Visual Impact Assessment – more of the same

Comments on GBD's individual VI assessments.

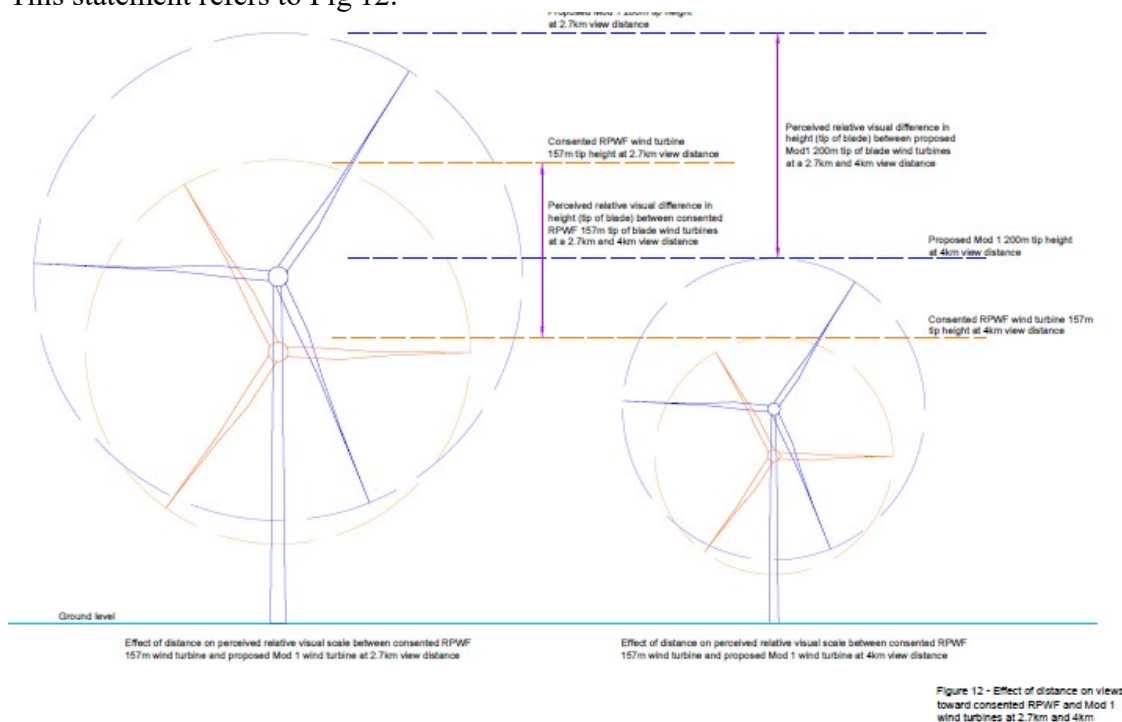
For some years, Mr Andrew Homewood from Green Bean Design has claimed that the perceived height of turbines is inversely proportional, **exponentially**, to the distance between the viewer and the turbine.

“The photographs, illustrated in **Figure 25**, demonstrate the degree to which the apparent visible height of a wind turbine decreases with increasing distance (in a negative exponential relationship)” (Bango wf LVIA p52).

Whilst that claim has finally disappeared can anyone explain from Page 39 of the VIA

“From a view distance of 4km the *consented RPWF and* proposed Mod 1 wind turbines would be perceived at less than half the height of the proposed Mod 1 wind turbine when viewed at a distance of 2.7km.”

From a comparison with the same claim and diagram in the Modification Report (page 79), I assume the words I have italicized above should be deleted.

This statement refers to Fig 12.

Even as modified, the statement is incorrect. Figure 12 does not show that at all. Is this the last vestige of GBD’s claim that perspective lines are curved?
